PLANNING & ENVIRONMENTAL PROTECTION
COMMITTEE

TUESDAY 8 DECEMBER 2009 AT 1.30PM

**UPDATE REPORT &
ADDITIONAL INFORMATION**

BRIEFING UPDATE

2.2 The outline scheme approved (see attached plan) comprised three blocks - 2 blocks fronting onto Fletton Avenue with a central vehicular access and one block adjacent to the southern boundary of the site. Within the site there was a

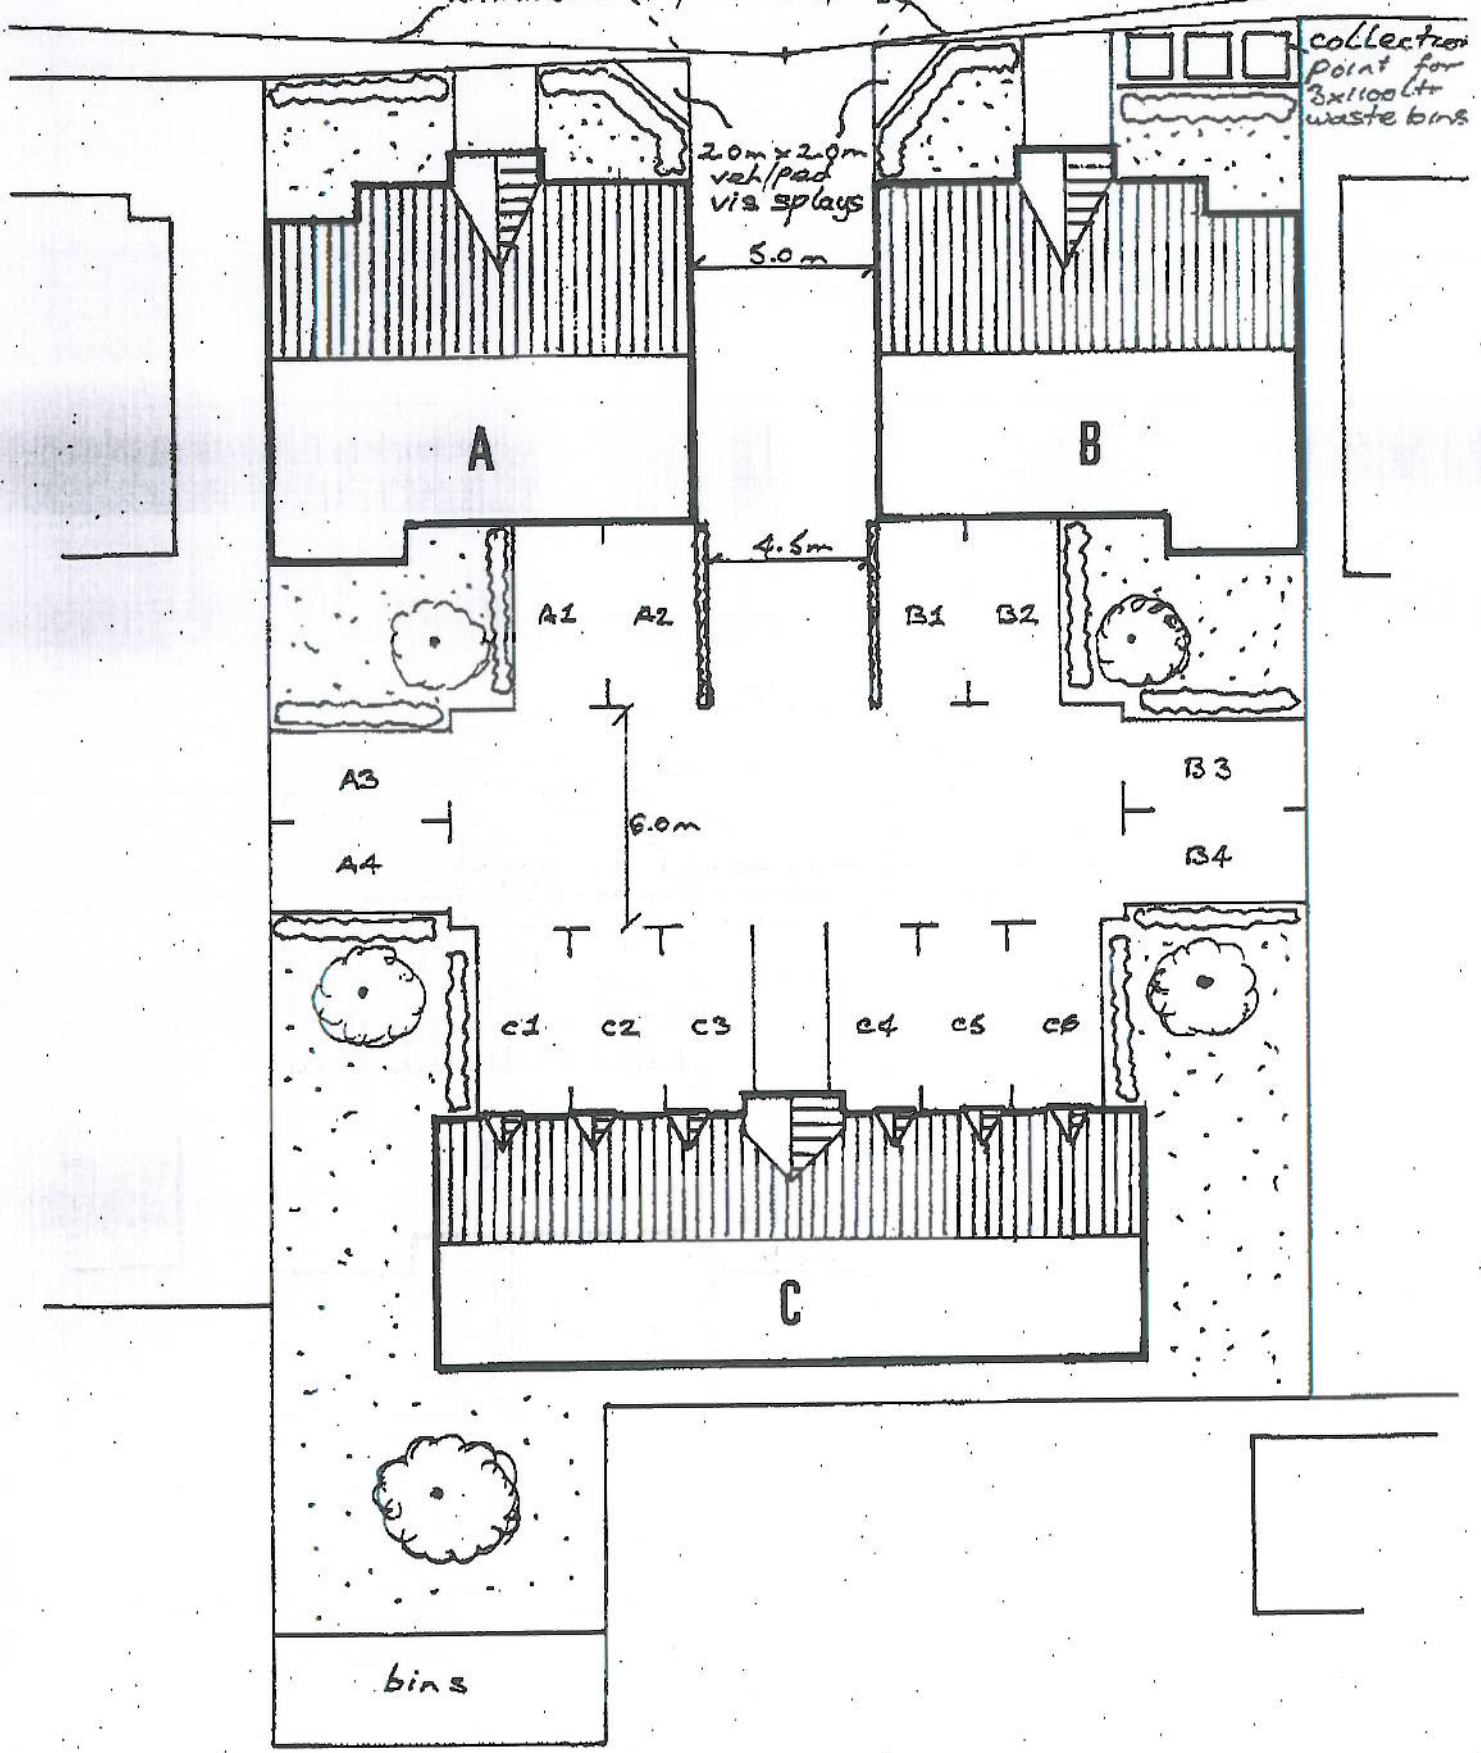
- The scheme is two storey in appearance to reflect the adjacent housing and the materials are characteristic of the area.
- The application was accompanied by a Design and Access Statement required by the Government since August 2006 superseding site appraisals.
- The bay window design reflects the design of the adjacent houses and does not obstruct any visibility splays.
- As a brownfield site previously covered with buildings and concrete there would be no loss of trees.
- The layout accords with all safety requirements.
- The tenure of the flats is not material consideration.
- The principal outlook from Block C is towards the central courtyard with

kitchen, bathroom and bedroom 2 at the rear.

- The development comprises a high density scheme according to Government policy for a site only one mile from the city centre on a main bus route.
- The scheme has been designed to complement the existing houses.
- The buildings are 2 and 2 ½ storey only.
- External fire escapes are unnecessary and heating ducts are a Building Regulations matter.
- The siting of the proposed blocks are as originally approved.
- There will be no overlooking of existing properties or loss of light.
- The parking provision accords with the City Council standard.
- The refuse storage areas will be managed as part of the overall management of the site.
- Drainage is a Building Regulation matter.
- This scheme accords with previous planning approvals.

- The proposal is for a residential use replacing a commercial use and will not result in increased noise.
 - Building work was lawfully commenced under the approval granted in June 2009.
 - There is already a variable building line to Fletton Avenue.
 - Loss of property values is not a material planning consideration.
 - Flats will provide for a variety of accommodation.
 - Damage by construction work is not a planning matter.
 - The on-site amenity space covers 22% of the site.
 - The development will not affect neighbouring trees.
 - The scheme accords with Government planning policy and saved Local Plan policies.
 - There is no requirement for the applicant to undertake pre-application consultation.
 - The Manor Drive visibility will not be affected.
-

- Parking provision is as originally approved.
- Landscaping is proposed to the frontage and within the site.
- Lighting details will be agreed.
- The internal layouts have not changed to the plans previously approved.
- Access to the flats will accord with the Disability Discrimination Act 1995 and Part M of the Building Regulations.
- Flues will not interfere with access to the site.
- The car parking will not interfere with the opening of windows which are set 1.0m above ground level.
